寄件者: stndp/PLAND  
寄件日期: 2024年08月12日星期一 10:11  
收件者: Cheryl Tsz Man TSANG/PLAND; Ryan Chi Kin HO/PLAND  
主旨: Fw: \*Restricted: 就A/NE-MKT/36申請回應環保署部門意見  
附件: 474 渠務示意圖.pdf

**From:** faith yu <[REDACTED]>  
**Sent:** Friday, August 9, 2024 7:06 PM  
**To:** tpbpd/PLAND <[tpbpd@pland.gov.hk](mailto:tpbpd@pland.gov.hk)>  
**Subject:** 就A/NE-MKT/36申請回應環保署部門意見

申請用途：擬議臨時汽車維修工場和露天  
停放汽車（只限旅遊巴士）（為期三年）

圖目：渠務示意圖

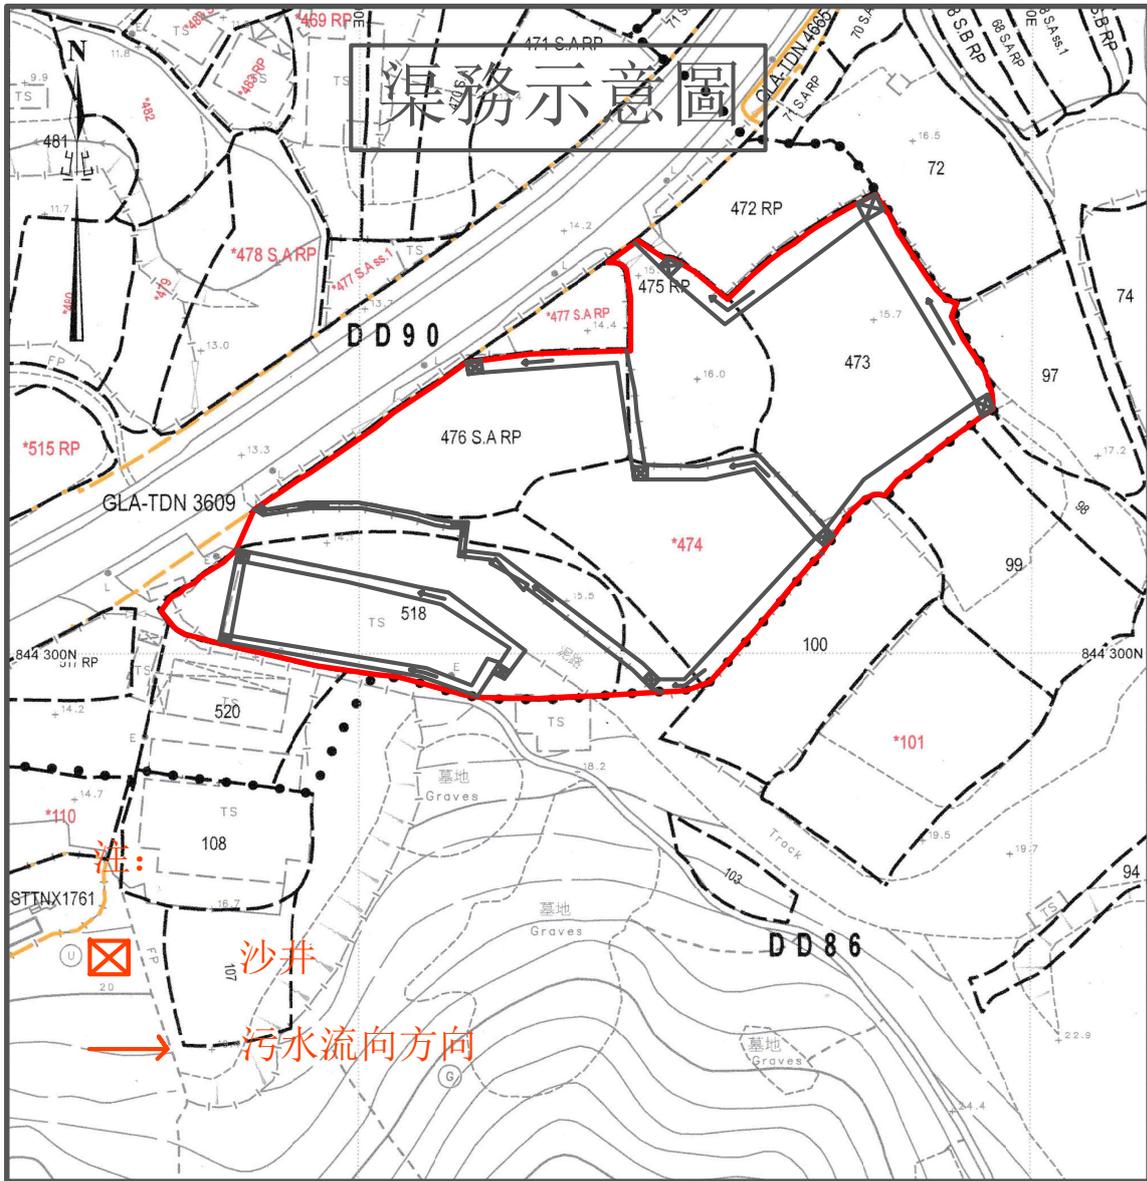
尊敬的城規會和環保署辦事人員你們好，我是A/NE-MKT/36的經辦人余生，是次來郵為回復此申請，環保署提出的有關污水處理設施的問題。就此地段的污水處理問題，在圖表渠務示意圖中，申請地點四周都用聚水溝包圍，首先防止污水未經處理排出場外，然後，每一小段聚水溝之間都設置了沉澱池（沙井）和截油器，過濾油污和阻隔垃圾，防止它們污染和堵塞污水渠，令到排入污水渠的都是經過處理的污水，所以不會對周邊環境和污水渠造成不好的影響，另外我們也會頻繁清理污水處理設施。
